PIC32MK General Purpose and Motor Control (GP/MC) Silicon Errata and Data Sheet Clarification

The PIC32MK General Purpose and Motor Control (GP/MC) family of devices that you have received conform functionally to the current Device Data Sheet (DS60001402F), except for the anomalies described in this document.

FIGURE 1: POSC CRYSTAL CIRCUIT

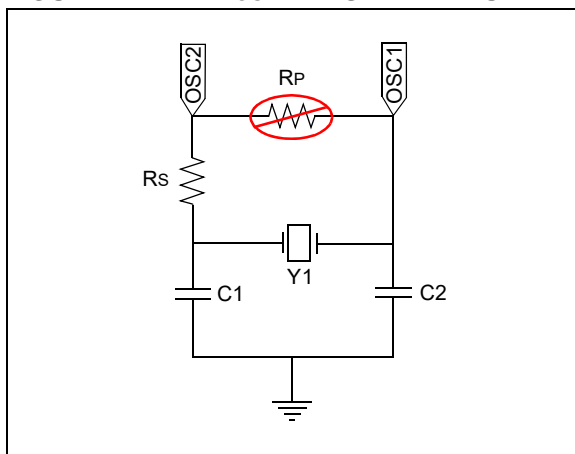
The POSC supports only specific crystal operation, as provided in [Table 1](#).

The Primary Oscillator (POSC) has been characterized to operate at 8 MHz and 12 MHz when the circuit shown in [Figure 1](#) is implemented and the operating conditions provided in [Table 1](#) are met.

Crystal Frequency (see Note 1)	Series Resistor Rs	POSC Gain Setting POSCGAIN<1:0> (DEVCFG0<20:19>)	POSC Boost Setting POSCBOOST (DEVCFG0<21>)
8 MHz	2 kΩ	'0b00 (GAIN_0)	'0b1
12 MHz	1 kΩ	'0b00 (GAIN_0)	'0b1
24 MHz ⁽³⁾	0	'0b00 (GAIN_0)	'0b1

FIGURE 2: RESET SUPERVISOR CIRCUIT

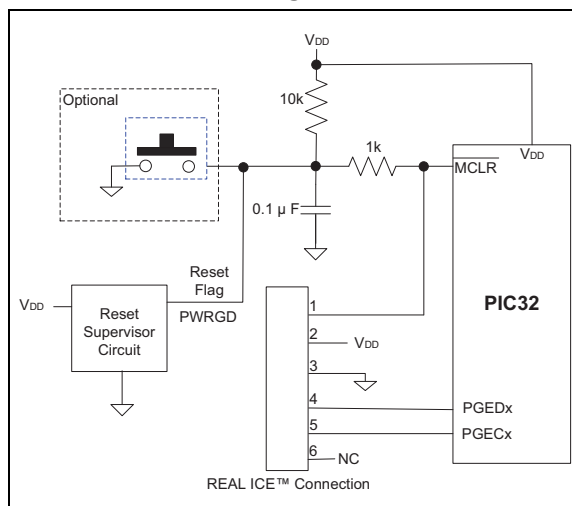
On a BOR event, $V_{POR} < V_{DD} < V_{BOR}$, a Reset is not generated when the BOR threshold is reached. System clocks will stop with all I/O pins functions frozen in their present state until either V_{DD} falls to V_{POR} or V_{DD} returns to above V_{BOR} . The user must assess if this V_{DD} brown-out condition and the resulting frozen I/O pin state has an adverse effect on their application (UART, PWM, I/O, OC, etc.).

Use an external Reset supervisor/monitor (see Figure 2). Some LDO regulators, as listed in Table 4, have an embedded reset supervisor included. The required minimum reset trip voltage of the supervisor should be at least $(V_{BOR} + 0.5V)$ with the SMCLR bit (DEVCFG0<15>) = 0 and the BORSEL bit (DEVCFG2<29>) = 1 in the Configuration Words. This means that the minimum V_{DD} operating voltage of the application needs to be above the reset supervisor maximum trip voltage at [Reset Trip (max) + 0.2V], (i.e. Application $V_{DD(MIN)} = \sim(V_{BOR} + 0.5V + 0.2V)$). The reset supervisor should have an open drain output so as not to interfere with the MPLAB

programming/debug tools. This workaround assures that MCLR will generate an internal POR and reset the I/O pins before the V_{BOR} trip point.
